**LEVY NUCLEAR PLANT, UNITS 1 AND 2
DOCKET NOS. 52-029 AND 52-030
RESPONSE TO REQUEST FOR ADDITIONAL INFORMATION LETTER NO. 095 RELATED TO
PROBABLE MAXIMUM SURGE AND SEICHE FLOODING**

**Levy Nuclear Plant Units 1 and 2
Response to NRC Request for Additional Information Letter No. 095 Related to
SRP Section 2.4.5 for the Combined License Application, dated October 4, 2010**

NRC RAI NUMBER: 02.04.05-10

Figure RAI 2.4.5-10-1

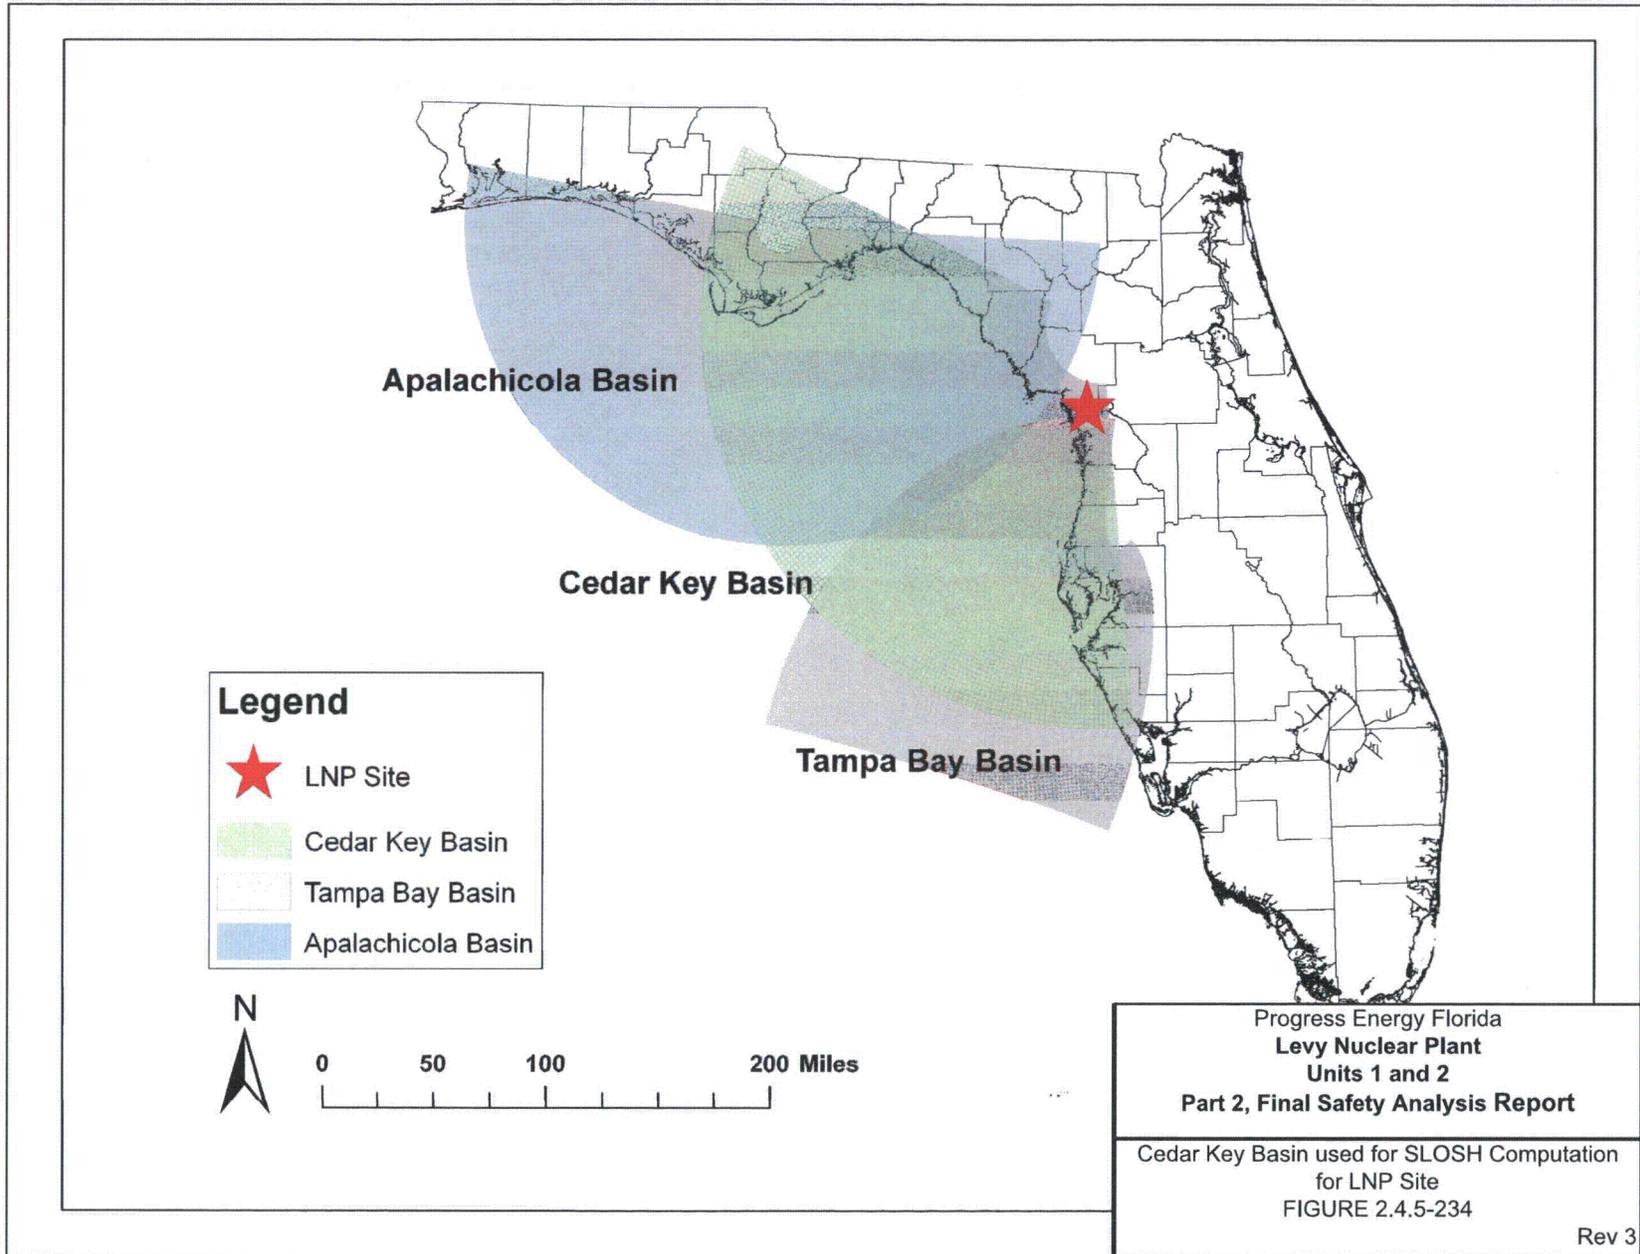
For purposes of modeling the coastline of Gulf of Mexico the NWS generated multiple SLOSH basin grids. The project site falls within the Apalachicola, Tampa and Cedar Key SLOSH basin grids (Figure RAI 2.4.5-10-1). The Cedar Key basin grid best represents the conditions specific to the project site and this basin was used for the PMH surge computation.

Figure RAI 2.4.5-10-2

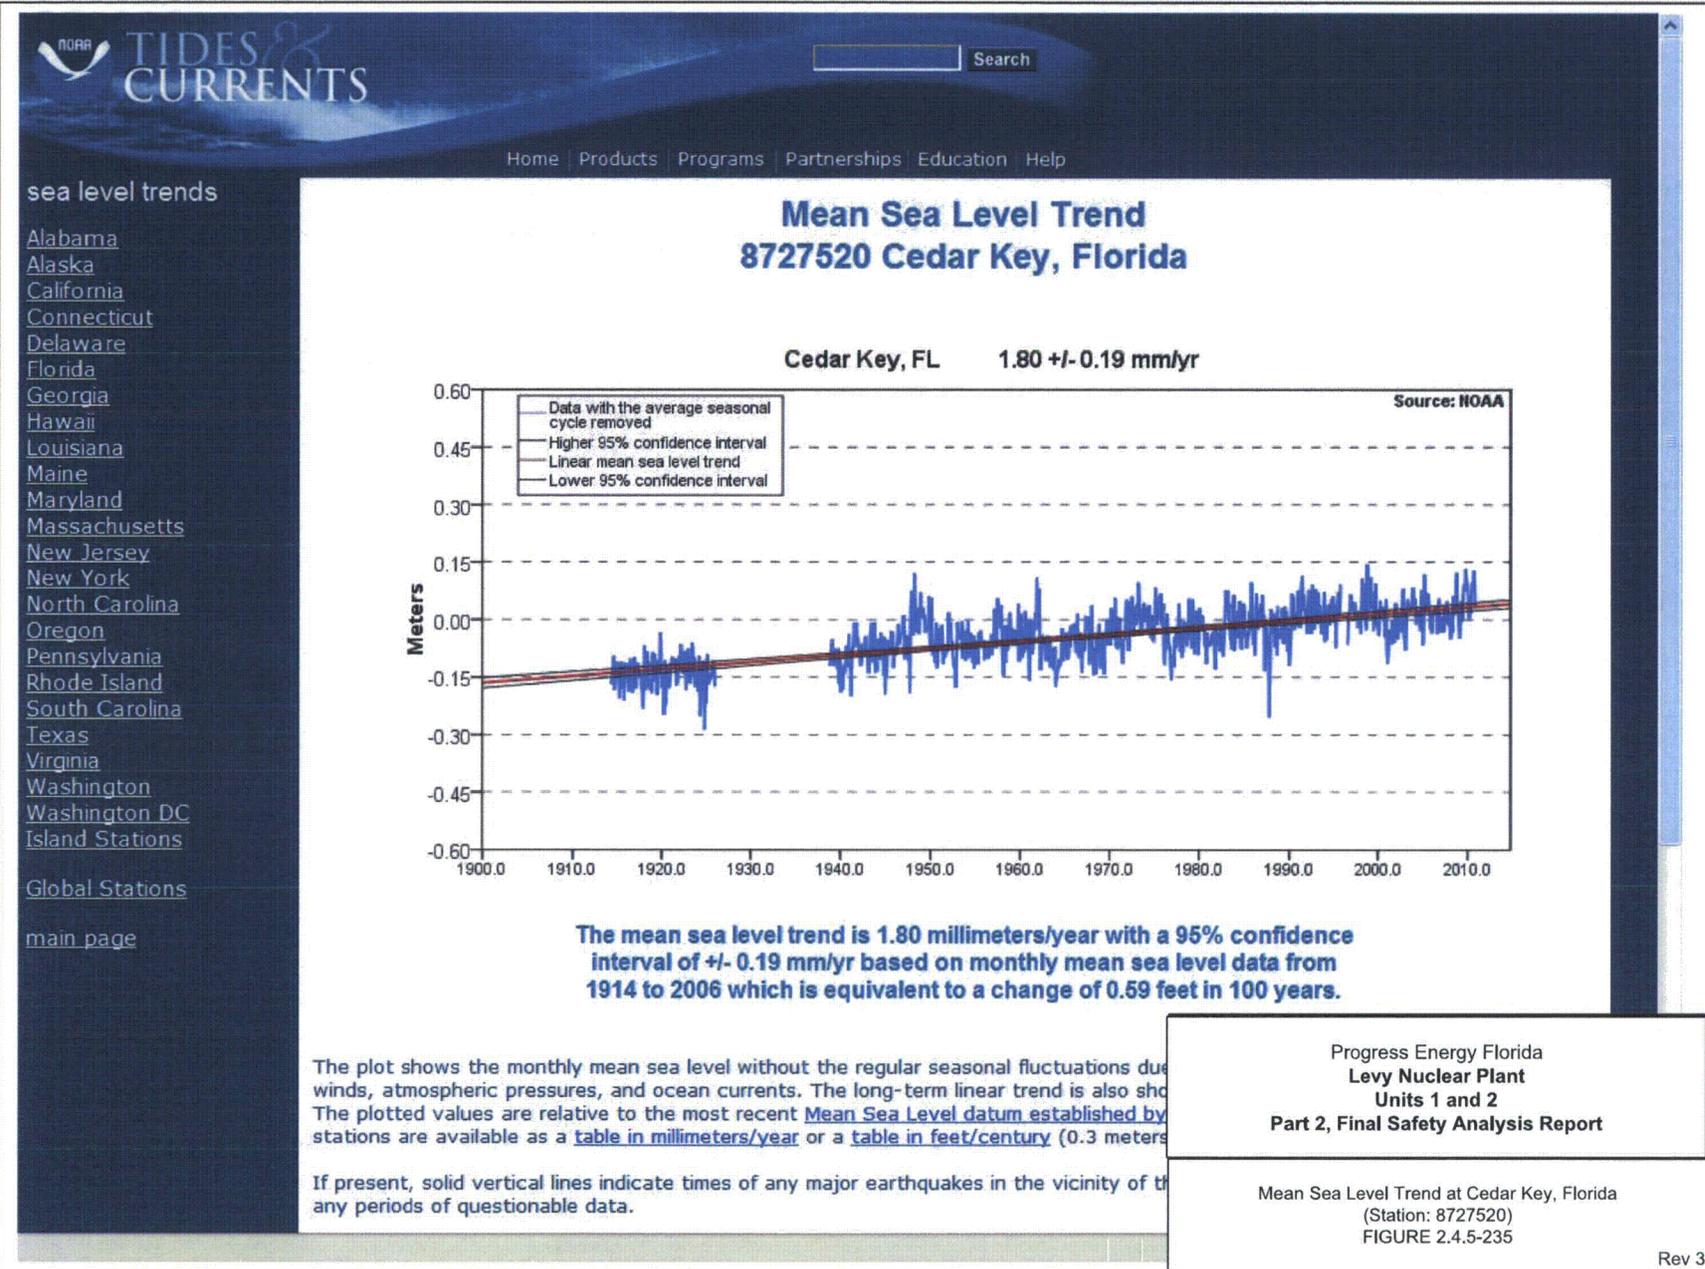
NOAA has evaluated sea level rise trends for each tide station. Figure RAI 2.4.5-10-2 provides the data for the mean sea level trend at the Cedar Key tide gauge, station 8727520. The mean sea level trend has been calculated by NOAA to be +1.80 millimeters/year with a 95% confidence interval of +/- 0.19 mm/yr based on monthly mean sea level data from 1914 to 2006. This is equivalent to a mean sea level rise of 0.59 feet in 100 years. The sea level rise of 0.59 feet in 100 years as evaluated by NOAA at the Cedar Key tide gauge station is appropriate for use as the sea level rise rate for the LNP site. Combining the initial water level of 3.23 feet NAVD88, corresponding to the 10% exceedance spring high tide, with long term sea level rise of 0.59 feet, an initial water level of 3.82 feet NAVD88 was used for all the SLOSH model runs.

Figure RAI 2.4.5-10-3

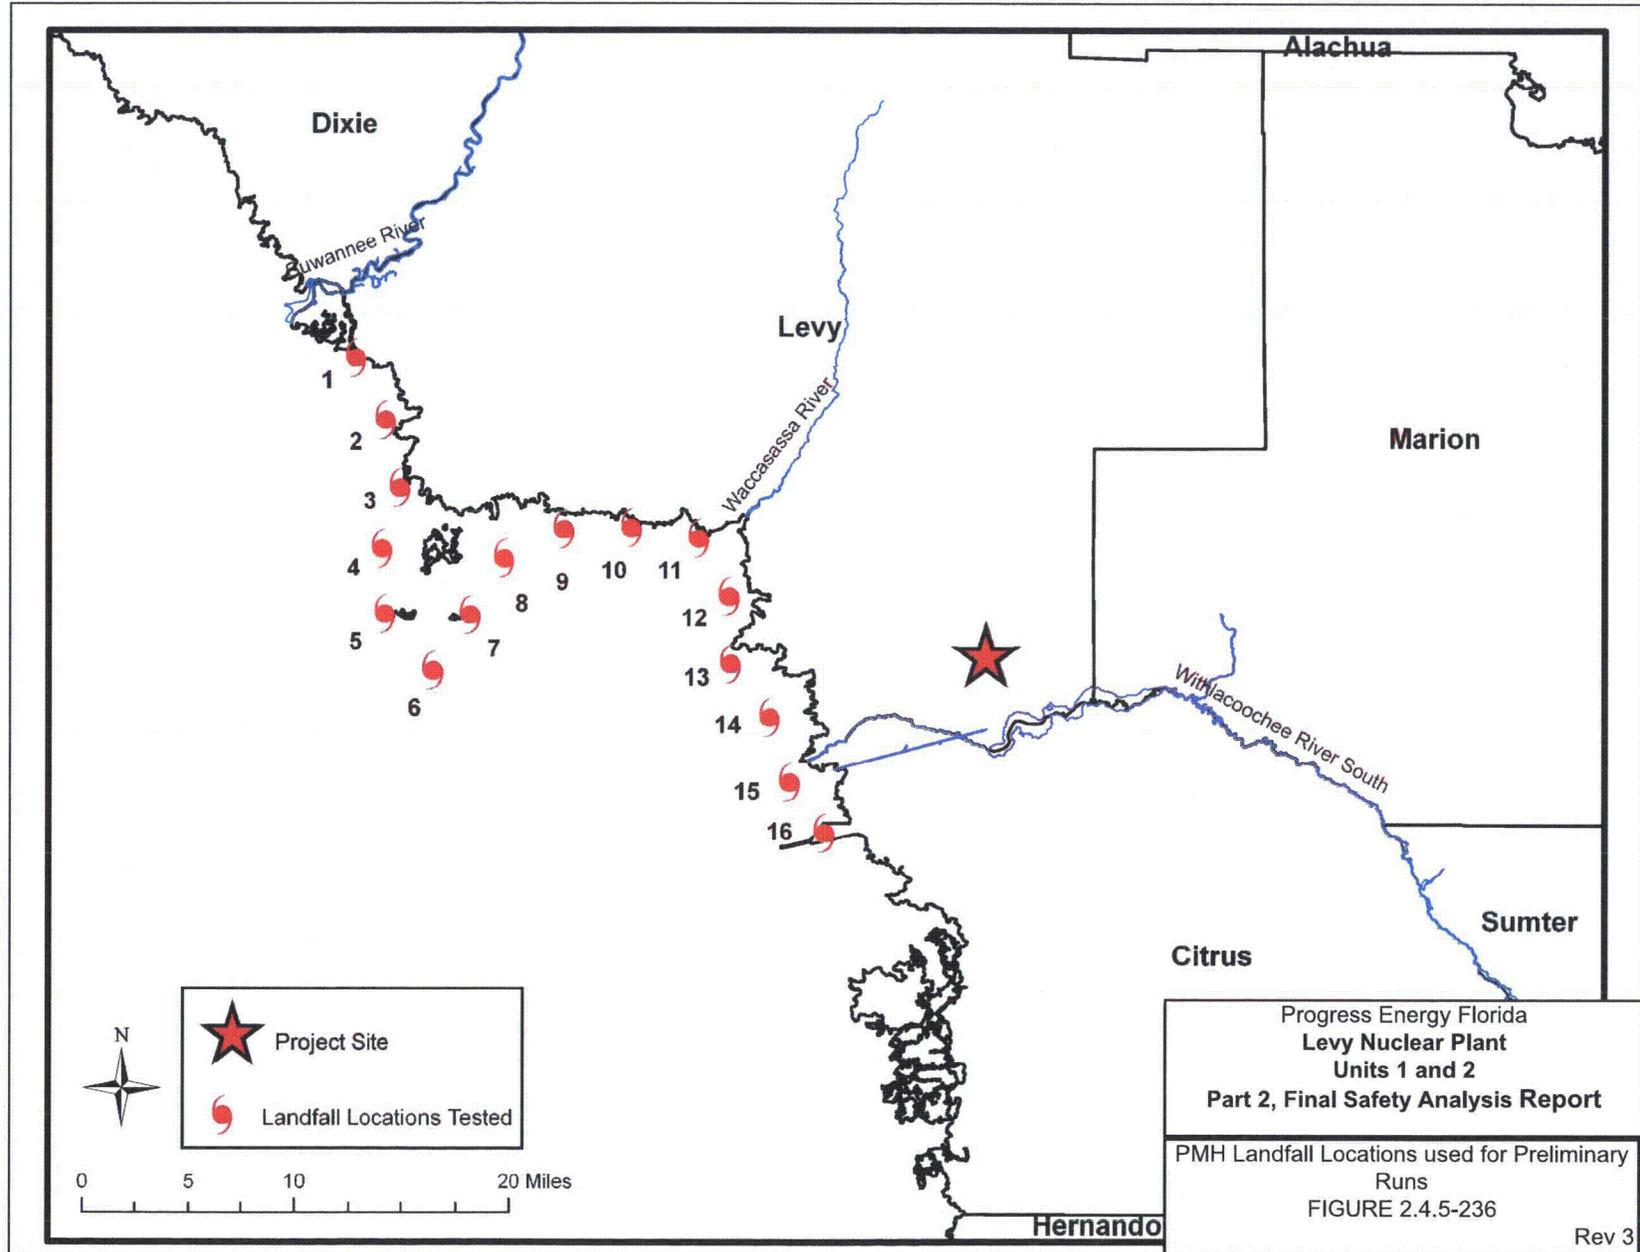
Figure RAI 2.4.5-10-3 provides a map of the landfall locations examined. As seen in Figure RAI 2.4.5-10-3, most of the landfall locations are north of the project site. This is because the northeast quadrant of a hurricane (north being the axis of the hurricane track) will produce the greatest surge due to the counter clockwise rotation of the wind field; therefore, it would be expected that landfalls north of the project site will produce the greatest surge. This was confirmed from the preliminary run results.

Table 3 provides a summary of the minimum and maximum surge values calculated for each of the landfall locations (Figure RAI 2.4.5-10-3). For all combinations of landfall locations, and forward speed, with the radius of maximum winds set at 7.5 miles or 17 miles, no surge is produced at the site. Only simulations that used a radius of maximum winds of 26 miles produced surge this far inland at the site.

Figure RAI 2.4.5-10-4

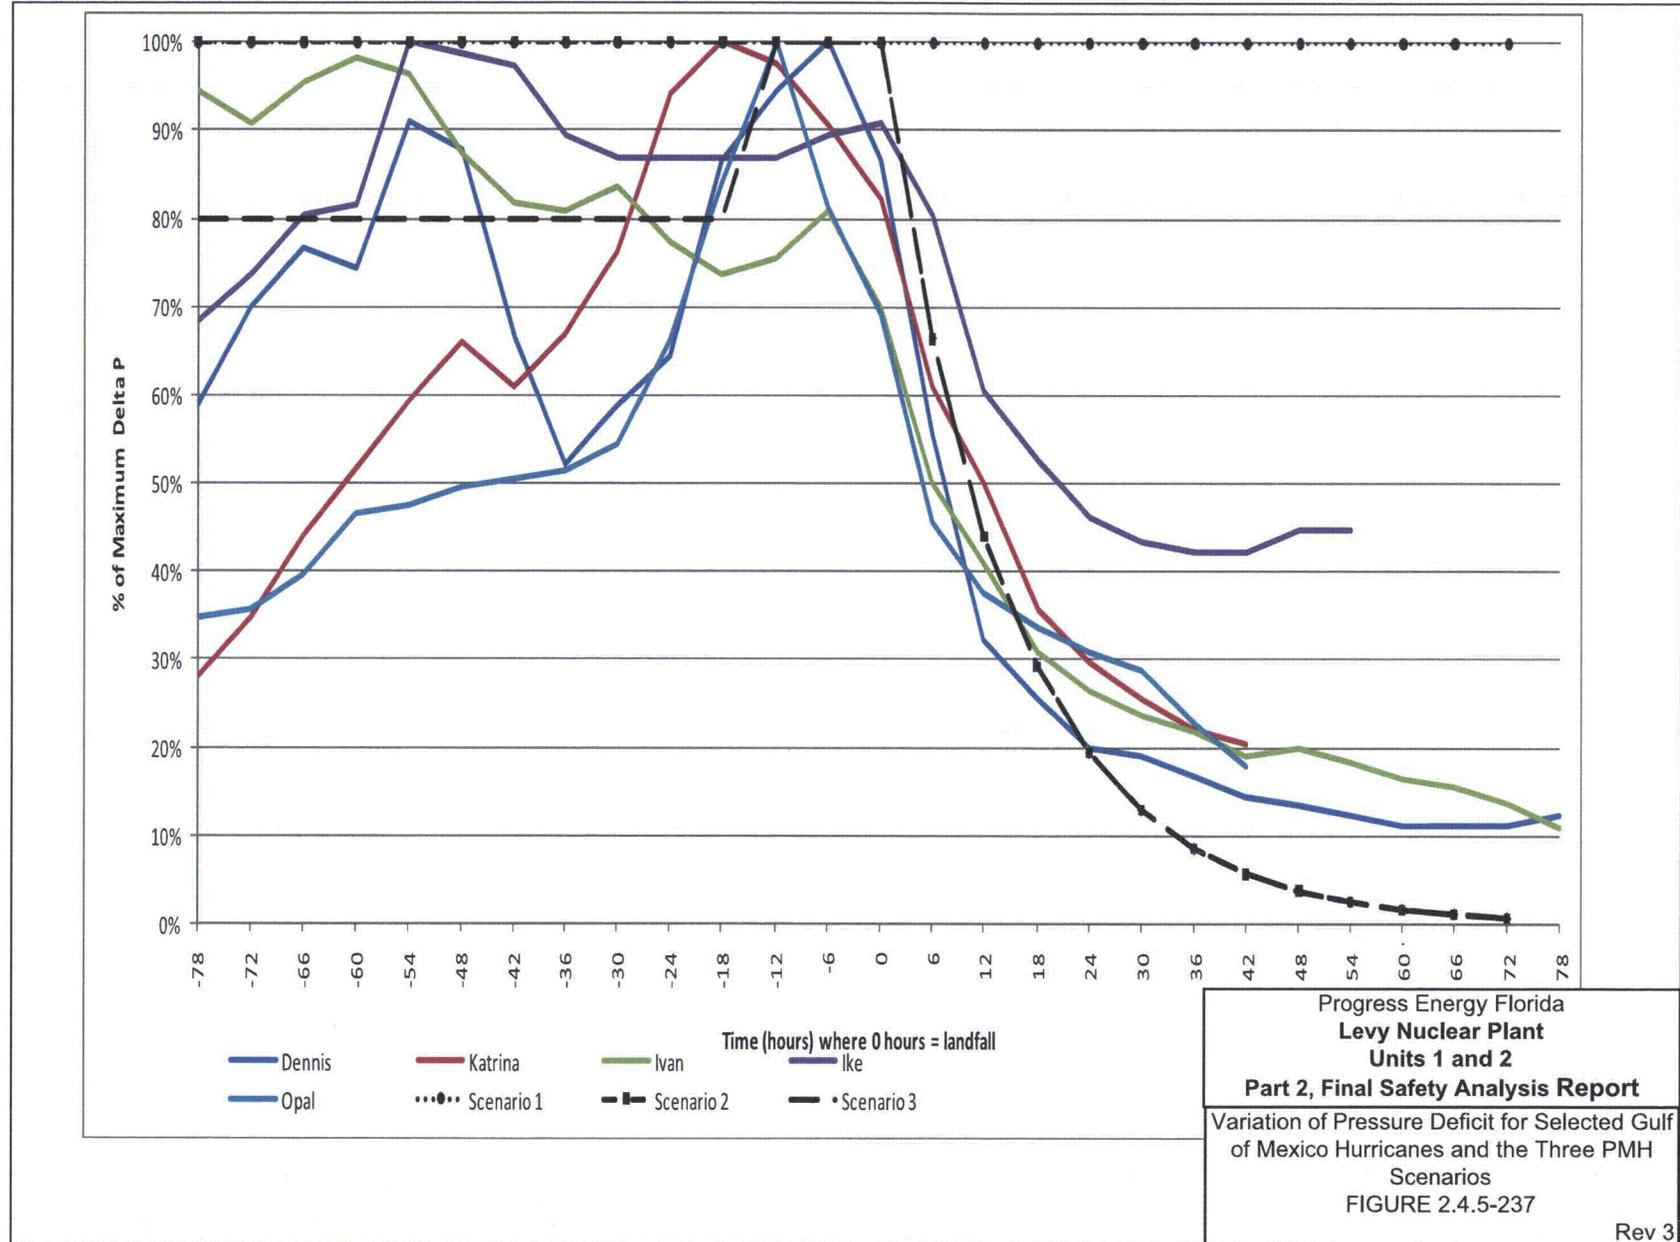
Three scenarios for the change in pressure were selected to examine the effect of a change in pressure deficit with respect to the time of landfall. Table 5 describes each scenario and Figure RAI 2.4.5-10-4 provides a graph of the change in pressure deficit with time for the three scenarios. Figure RAI 2.4.5-10-4 also provides a comparison with pressure data from significant hurricanes that made landfall along the Gulf of Mexico. It is seen that as the storms approach landfall (at time=0 hours) the pressure deficit increases with the maximum occurring before or at landfall. Figure RAI 2.4.5-10-4 shows that most of the storms also show a nearly linear ramp up of pressure deficit prior to landfall with an exponential decay after landfall. The decay after landfall follows the calculation of decay provided by Reference 5.
